# Access Compliance Report

## Public Rights-of-Way

| Intersection ID: 31503                  | Main Street: CHARIDGE_LN | Cross Street: STONEY_PLACE_CT           | Location: SW           |
| ADA ID: ED97D774AA04                    | Ramp Type: PerpDiag      | Initial Pass/Fail: Fail                 | Overall Compliance: No |

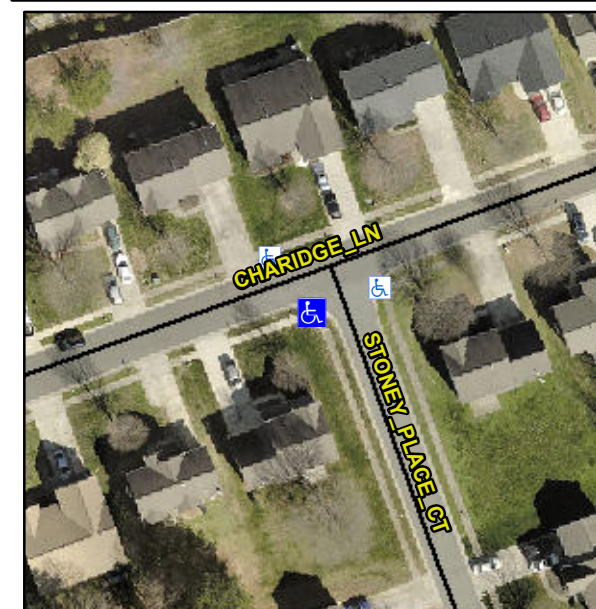
**Not Found, R304.5.1, R304.2.2, R304.5.3**

| Compliance | Description           | Data | Compliance | Description                 | Data |
|------------|-----------------------|------|------------|-----------------------------|------|
| N/A        | Ramp Length (in)      | 46.0 | No         | Ramp Slope (%)              | 10.5 |
| No         | Ramp Width (in)       | 33.5 | No         | Ramp XSlope (%)             | 8.8  |

**Remove & Replace Curb Ramp With Two New Directional Ramps or Equivalent.**
